Item Name: Dual High Back Seat Installation

DART SERVICE INSTRUCTION

TO AMEND INSTALLATION INSTRUCTIONS IIN-D350-689 REV. B AND INSTRUCTIONS FOR CONTINUED AIRWORTHINESS ICA-D350-689 REV. 1

REF. TCCA STC: SH02-33
REF. FAA STC: SR01620NY
REF. EASA STC: EASA.IM.R.S.01453
REF. TCA STC: 2005S03-09

FIGURE 1: UPDATES TO CROSS SECTIONS F-F AND M-M
 With reference to Figures 5 and 7 of IIN-D350-689
 (Figures 25-5 and 25-7 of ICA-D350-689)

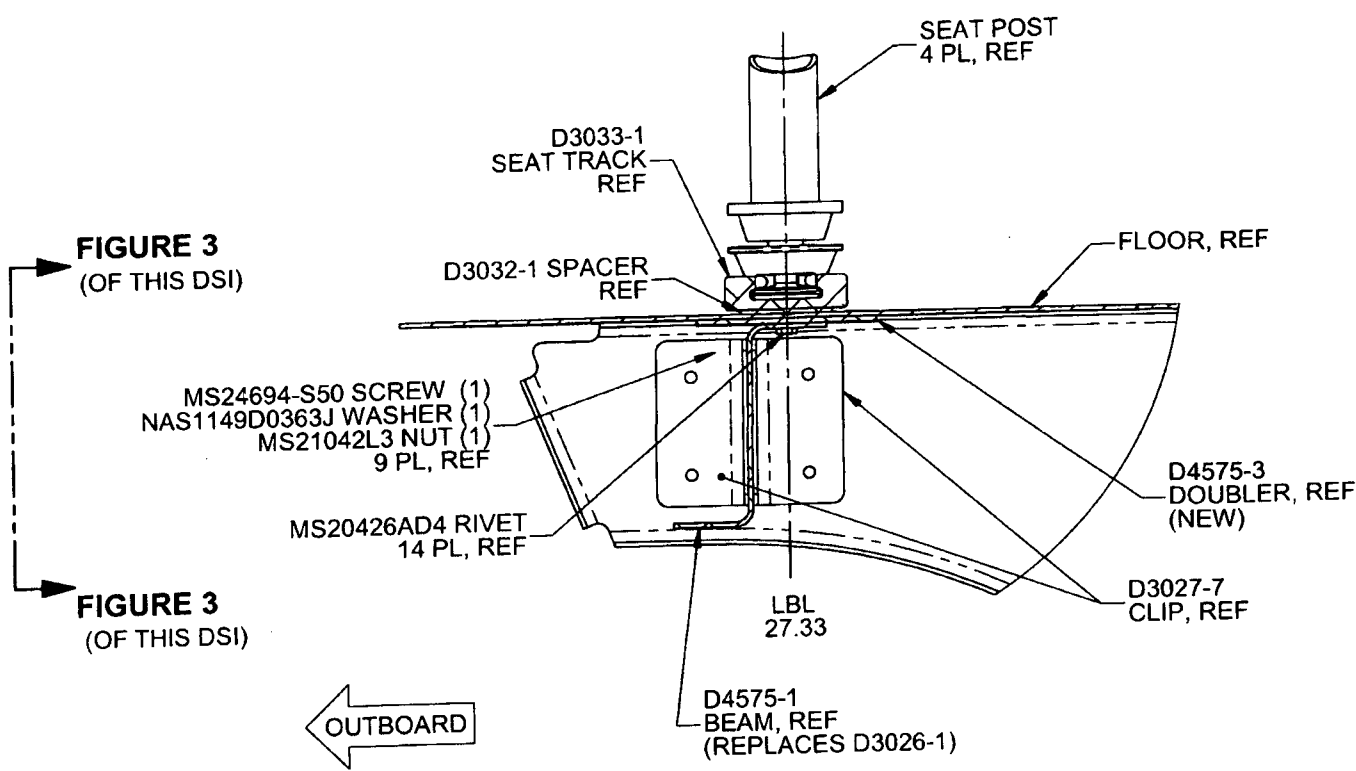
If there is an existing stringer at LBL 27.33, it will need to be removed from that location. Locate D4575-1 Beam, D4575-3 Doubler, and D3032-1 Spacer as shown in Figure 1 of this Service Instruction. Transfer drill existing holes from the aircraft floor to the D4575-1 Beam, D4575-3 Doubler, and D3032-1 Spacer. Ensure 1.0" to 1.5" rivet pitch and add additional holes if required. If there is no existing stringer, locate D4575-1 Beam, D4575-3 Doubler, and D3032-1 Spacer as shown in Figure 1 of this Service Instruction and drill Ø0.128" holes on a 1.0" to 1.5" pitch.

If there is an existing stringer at LBL 27.33, it will need to be removed from that location. Locate D4575-1 Beam and D4575-3 Doubler as shown in Figure 2 of this Service Instruction. Transfer drill existing holes from the aircraft floor to the D4575-1 Beam and D4575-3 Doubler. Ensure 1.0" to 1.5" rivet pitch and add additional holes if required. If there is no existing stringer, locate D4575-1 Beam and D4575-3 Doubler as shown in Figure 1 of this Service Instruction and drill Ø0.128" holes on a 1.0" to 1.5" pitch.

FIGURE 3: RELIEFS ON D4575-1/-3
(ONLY D4575-1/-3 SHOWN FOR CLARITY)
VIEW LOOKING INBOARD

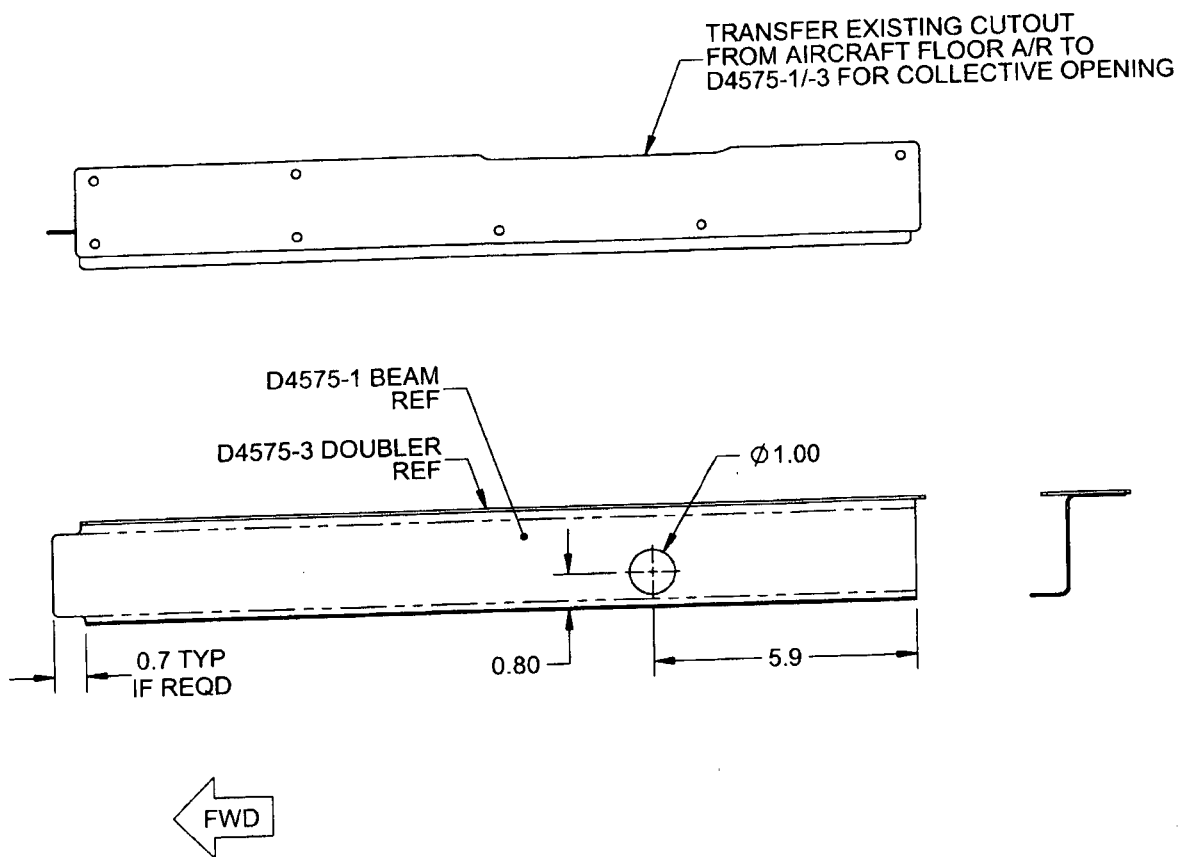
Note: Drill a Ø1.00" (Ø25.4 mm) hole in the D4575-1 Beam to clear extension tube of collective and cutout as required for clearance of collective opening and fwd bulkhead as shown in Figure 3 of this Service Instruction.

Note: Drill a Ø1.00" (Ø25.4 mm) hole in the D4575-1 Beam to clear extension tube of collective and cutout as required for clearance of collective opening and fwd bulkhead as shown in Figure 3 of this Service Instruction.
